Re: Proceeding on Motion of the Commission to Implement a Large-Scale Renewable Program and a Clean Energy Standard – Zero Emissions Target

These comments are in response to [comments](#) submitted by Sierra Club and Earthjustice dated June 14, 2024. These relate to my previously submitted [comments](#) recommending a study that the Commission should undertake with respect to the development and deployment of resources capable of achieving a zero emissions grid and other [comments](#) regarding the [presentation](#) by Zachary Smith of the New York Independent System Operator (NYISO) that described the attributes of the Dispatchable Emissions-Free Resource (DEFR). I believe that the Sierra Club and Earthjustice fail to appreciate the potential magnitude and duration of the wind and solar resources “gap” in their comments in Section 4: “Significant Modeling Gaps in NYISO’s Presentation at the Technical Conference Cast Doubts on the Operator’s Conclusion that New York Will Have a DEFR Need of 30 GW+.”

Figure 1: Dispatchable Resources Needed from Zero Emissions by 2040 Technical Conference
[Slide Presentation](#) Dispatchable Emission-Free Resources (DEFRs) by Zachary Smith NYISO

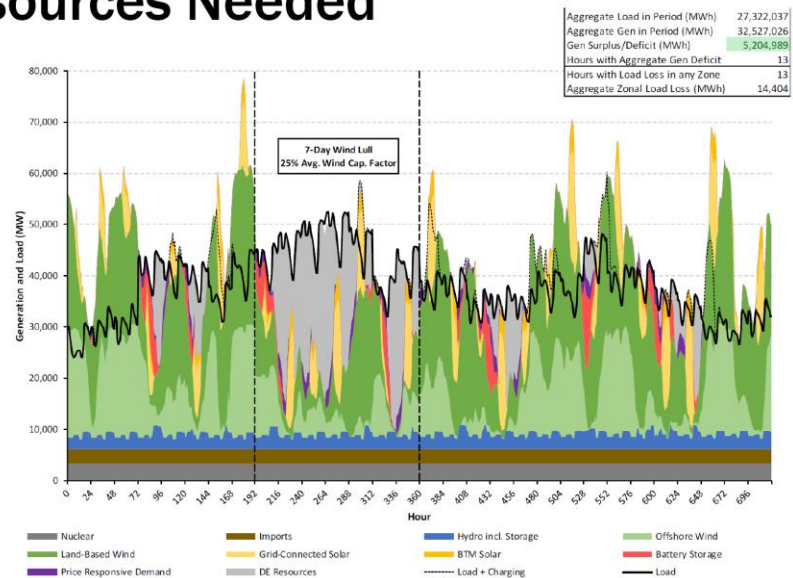
The SC&E comments characterized Zachary Smith’s slideshow at the “Characterizing the potential ‘gap’” Panel presentation during the technical conference as “particularly alarming”. The comments said that the slideshow suggested that New York will require 30 GW of DEFs. But said that “the analysis shown in slide 3 of Mr. Smith’s presentation has multiple flaws”:

The first flaw relates to the “Wind Lull” analysis. The “Wind Lull” analysis only uses three wind profiles (including just two upstate wind profiles) to determine whether a “Wind Lull” occurs. An analysis of “Wind Lulls” limited to two upstate profiles likely misses the diversity of wind in the NYISO footprint which includes wind in Zones B, C, and E in addition to other wind sites in Zones A and D aside from Niagara and Plattsburgh. Further, despite a maximum winter “Wind Lull” of five days in the historical record evaluated, the analysis determined that the winter “Wind Lull” period should be 7 days because “it is possible that there have been more severe wind lulls than in the time span we analyzed, and that there could be more severe wind lulls going forward, particularly if such outcomes are made more likely by climate change.” While this may be true, this assumption was not substantiated by any climate models or other analysis and should not be used as the basis for determining the length of winter “Wind Lull” periods to be evaluated. The limited number of wind profiles evaluated and unsubstantiated lengthening of the “Winter” wind lull period arbitrarily increase “wind lull” period lengths leading to a conservative assumption on wind availability and an overestimate of the DEFR gap.

I disagree with most of this. In the first place, there is a very high correlation of wind resources in New York. For example, I used a NYISO resource that provides [2021 wind production](#) and [2021 wind curtailment](#) data that list the hourly total wind production and curtailments for the entire New York Control Area (NYCA) as shown in the following [table](#). All of the wind in the state must be highly correlated if 25% of the time only 7% of the state total wind capacity is available. Only using two upstate wind profiles is not the best practice but neither is it particularly bad for the highly correlated New York data. In addition, this concern is addressed in the more recent work by the NYISO that was not available at the time of the Technical Conference.

As shown in the preceding section, the concern about assuming a 7-day wind lull when the short period analyzed only found a 5-day wind lull is not an issue. As the period of record increases the length of the gap increases and the NE-ISO found that it was appropriate to evaluate 21-day periods. In addition, SC&E comments overlook the need to consider the state of the energy storage resources going into a shorter poor resource availability period. If moderate weather conditions prevented full energy storage capacity, then that will affect the ability of the system to provide sufficient electric energy when it is needed the most.

The SC&E comments go on to claim that the NYISO Table 1 analysis did not reflect correlated wind, solar, and load data. If true, then I agree. However, subsequent analyses by the NYISO and NE-ISO do use correlated hourly meteorological data, estimate wind and solar resource availability, and project loads based on that data. All those results show that the magnitude of this problem is greater than appreciated in the comments. The SC&E conclusion that “If correlated wind, solar, and load shapes (without arbitrary adjustments) were used, it is likely that the DEFR Capacity need would be significantly reduced” is wrong. Correlated data over the period of record show that the DEFR capacity requirement will be greater than shown in the Smith analysis at the Technical Conference.
